Agenda
Village of Glen Ellyn
Architectural Appearance Commission Meeting
Wednesday, June 14, 2023
7:00 PM
Glen Ellyn Civic Center, Galligan Board Room

- A. Call to Order**
- B. Approval of Draft Minutes**
 - 1) Approval of May 2, 2023 Meeting Minutes
- C. Public Comment (non-agenda items)**
- D. Exterior Appearance Review**
 - 1) 800 St. Charles Road: Exterior Appearance Approval for an Addition to the Ackerman Sports and Fitness Center (Glen Ellyn Park District)
 - 2) 49 Deicke Drive and for a new facility at 26 Newton Avenue: Exterior Appearance Approval (B.R. Ryall YMCA)
 - 3) 604-610 Roosevelt Road: Exterior Appearance Approval
- E. Trustee Liaison's Report**
- F. Chairman's Report**
- G. Staff Report**
- H. Other Business and Adjournment**

FROM: Michael D’Onofrio, Planning Consultant

LANDSCAPE PLAN

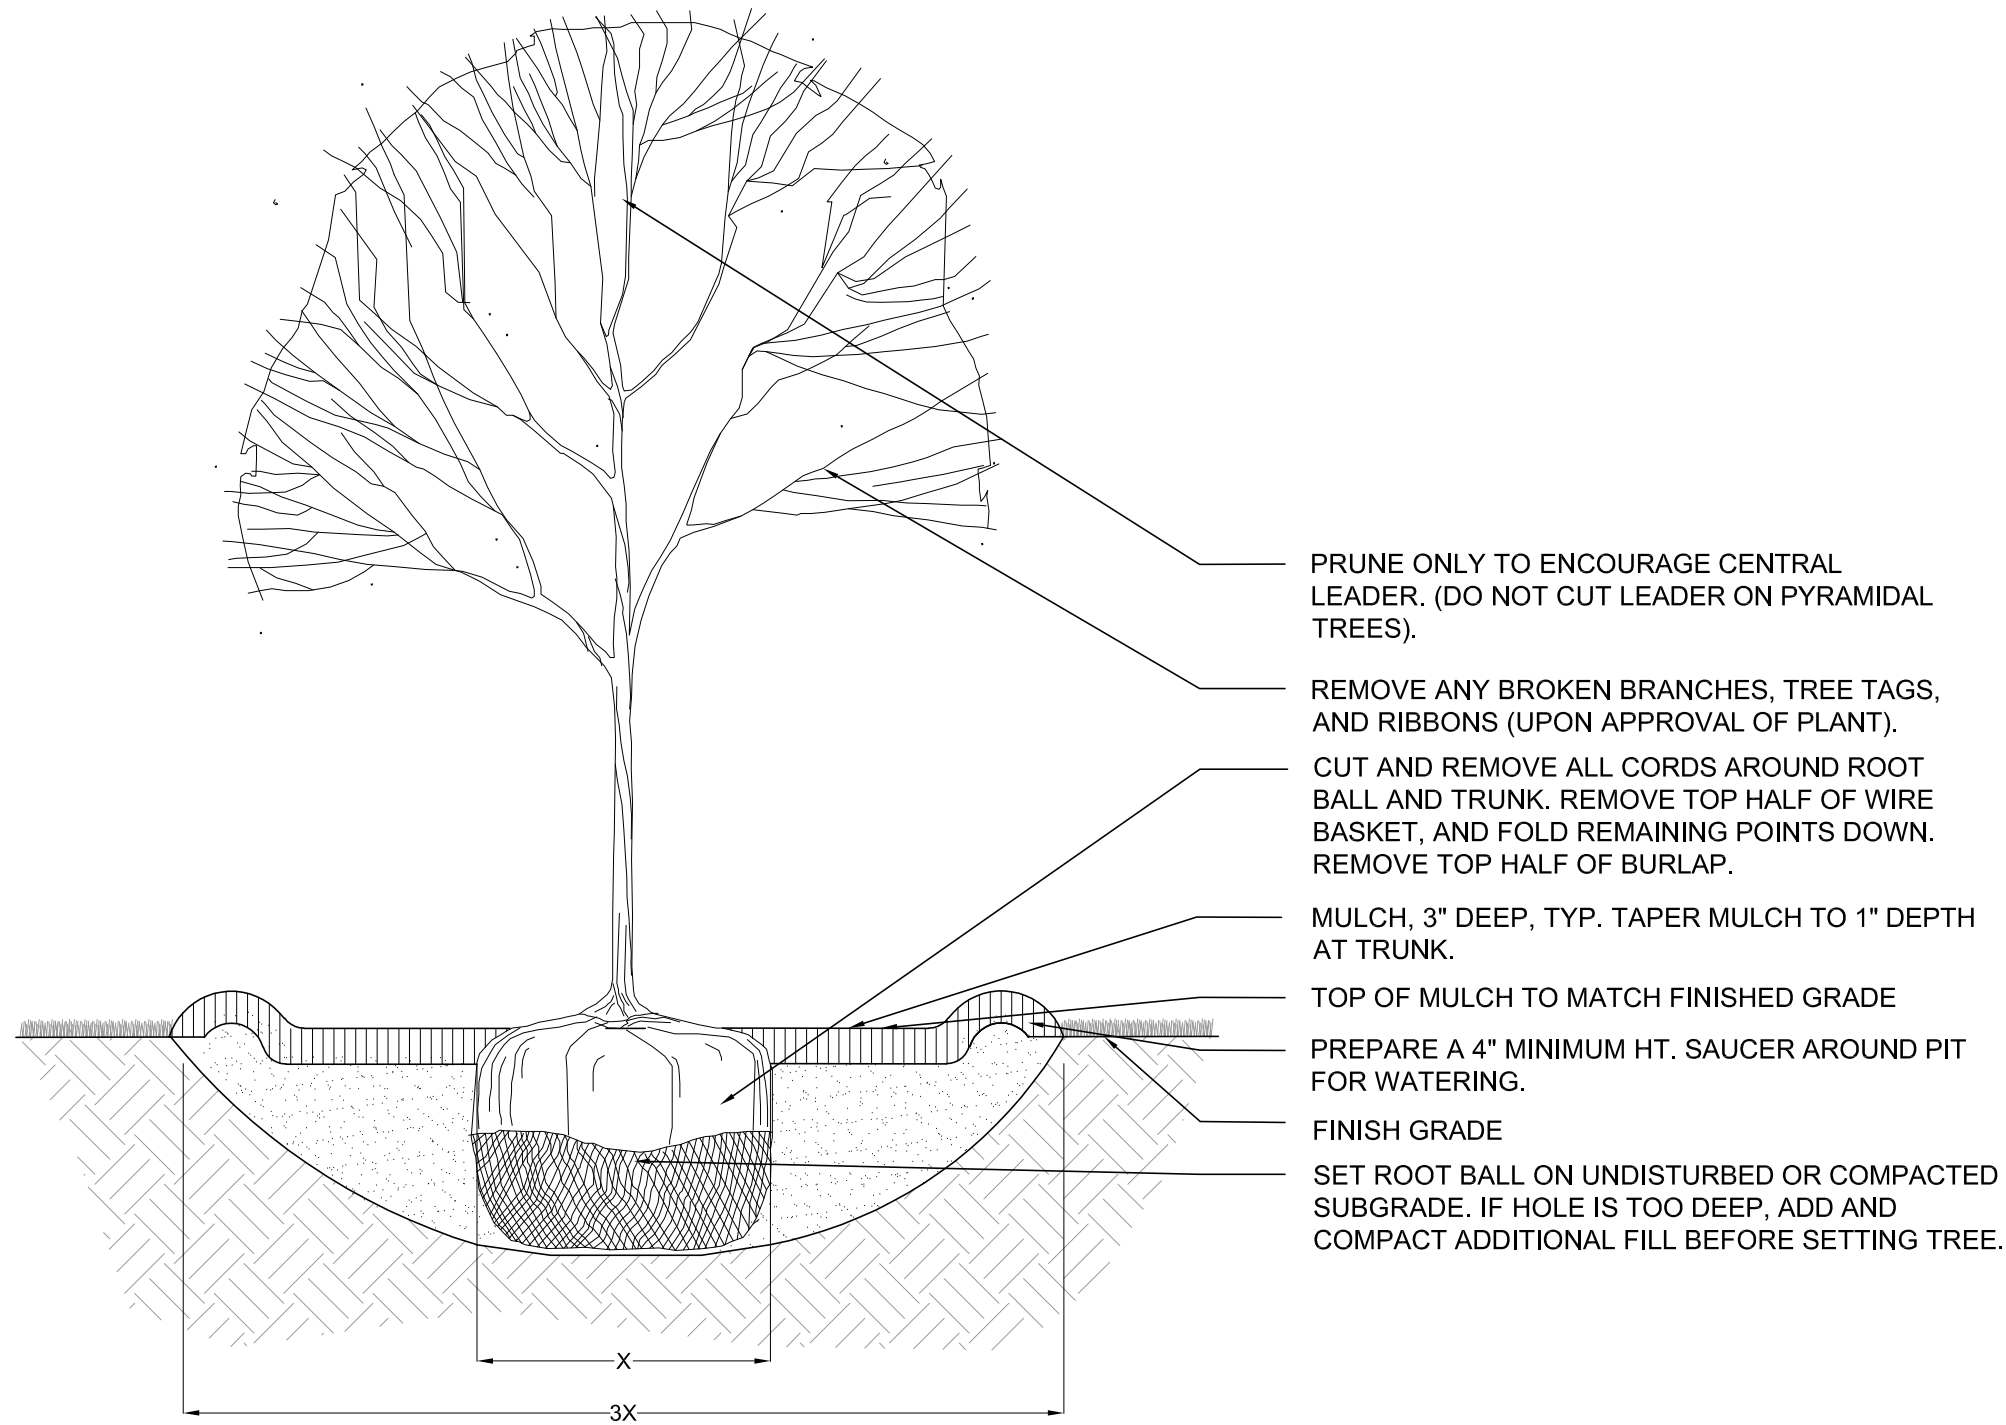
Landscaping. The petitioner has submitted a landscape plan which is included in your review materials (Page L1.00 Landscape Plan). Please note the landscape plans associated with the parking lot expansion were discussed above in the Site Plan comments. The petitioner is proposing to install plantings along the entire north wall of the existing and new buildings, as well as along the west wall of the addition. The proposed plantings include a variety of evergreen and deciduous shrubs, perennials, and ornamental grass.

Comments: the proposed plantings are consistent with those called for in Appendix B. Second, the width of the landscaped area is five feet which meets the Guidelines standard. Finally, given the mix of evergreens and deciduous shrubs, along with perennials and ornamental grasses, it should provide color throughout the growing season.
